AMENDMENTS TO THE DRAWINGS:

REMARKS/ARGUMENTS

FIG. 1

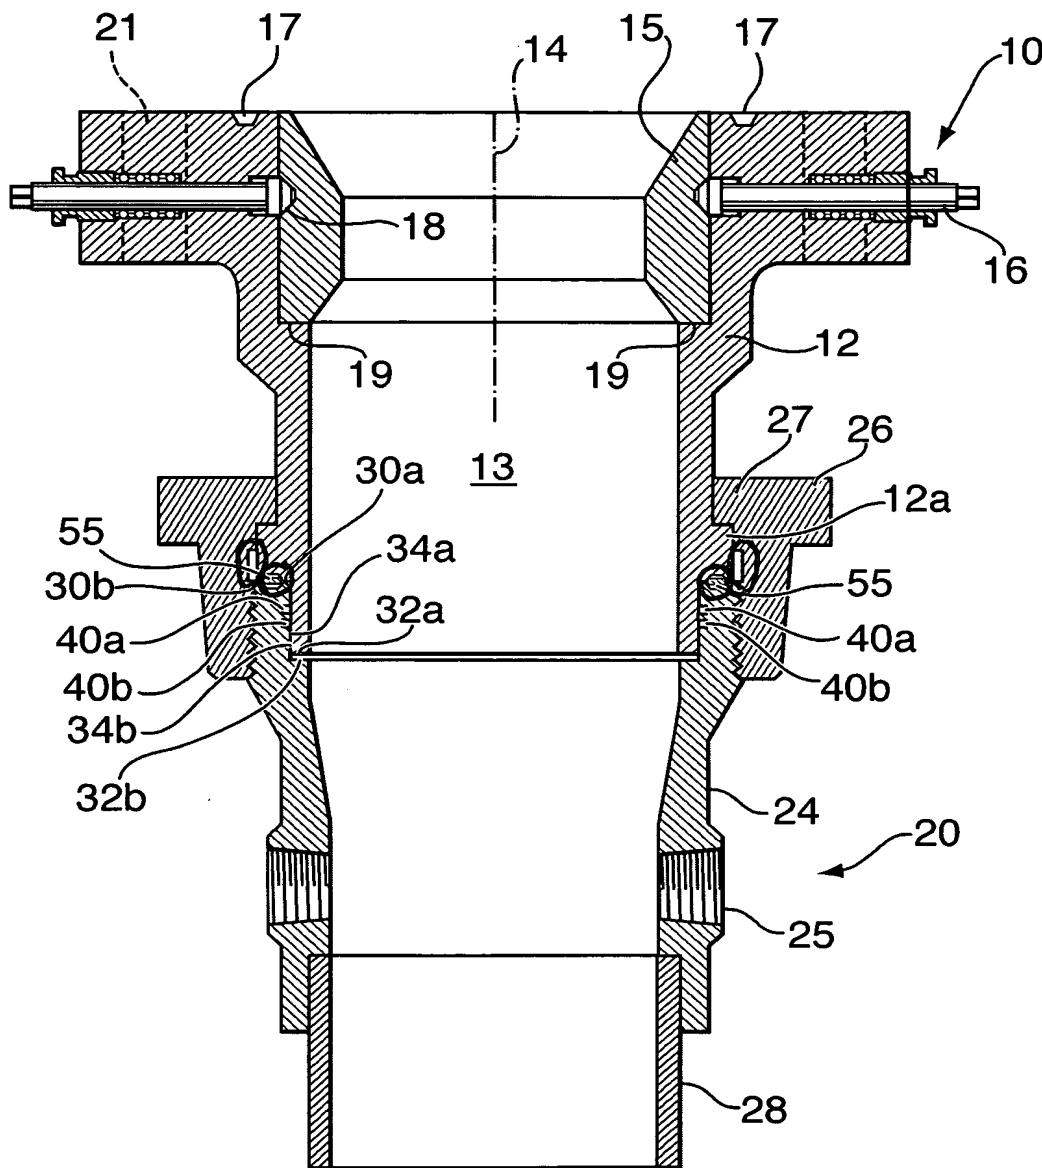
Furthermore, Figures 1-7 have been amended to correct the engagement of the lockdown nut and the flange body annular shoulder, to conform with the original drawings submitted with the present application. Figures 1-4 have also been amended regarding the ring gasket.

FIG. 2

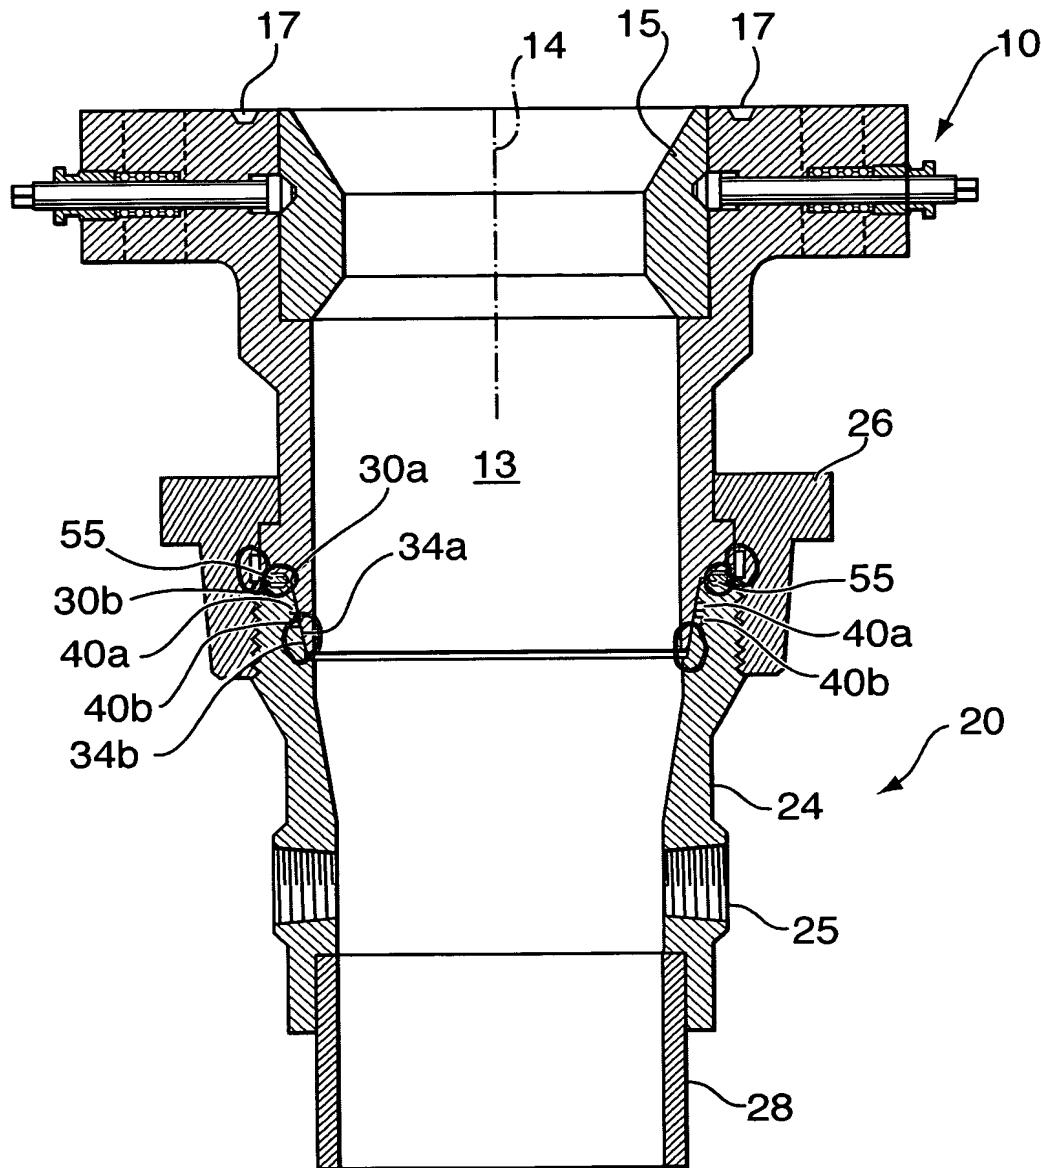
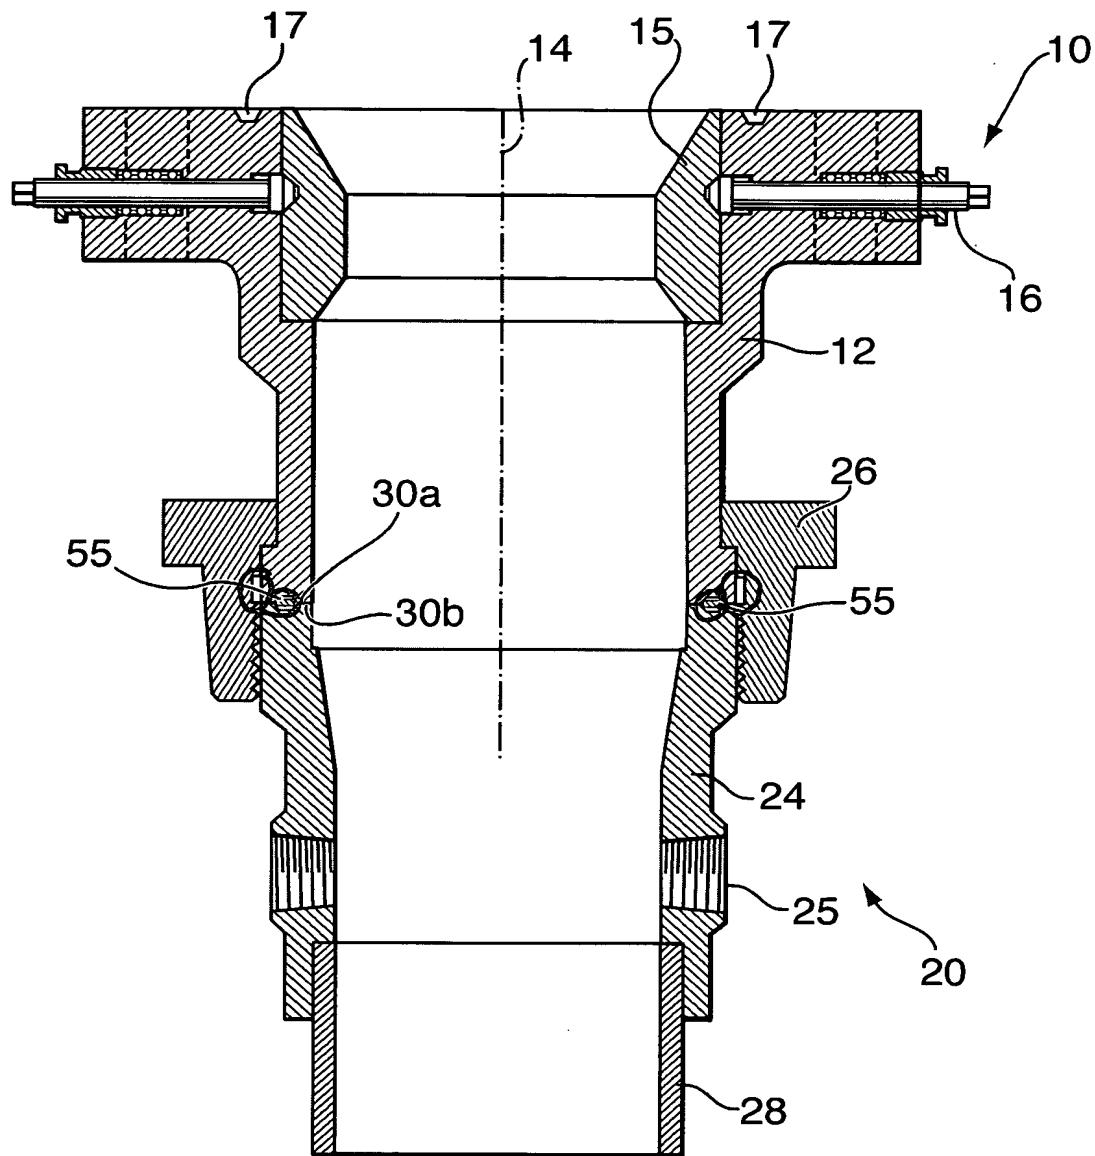
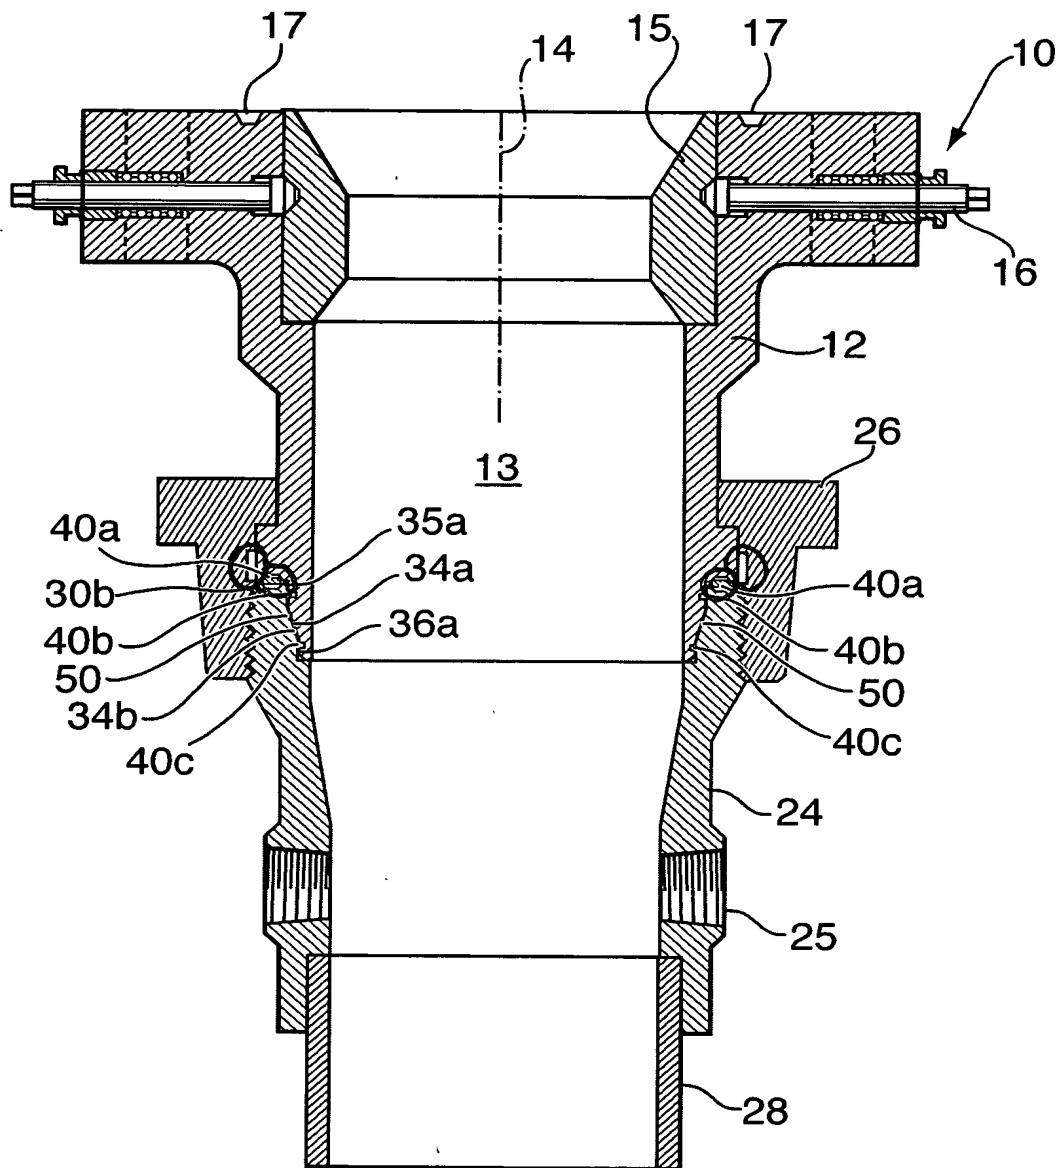
The attached sheet of drawings includes changes to Figure 2. This sheet, which includes Figure 2, replaces the original sheet including Figure 2. In Figure 2, a draftsman's error has been corrected to conform the formal drawing of Figure 2 with the informal drawing originally submitted with this application on filing.

The drawings were objected to because surfaces 34a and 34b in Figure 2 of the formal drawing submitted in this application by way of voluntary amendment failed to show the frusto-conical shape shown in Figure 2 of the informal drawings submitted on filing of the application.

The draftsman's error has been corrected. No new matter has been added.
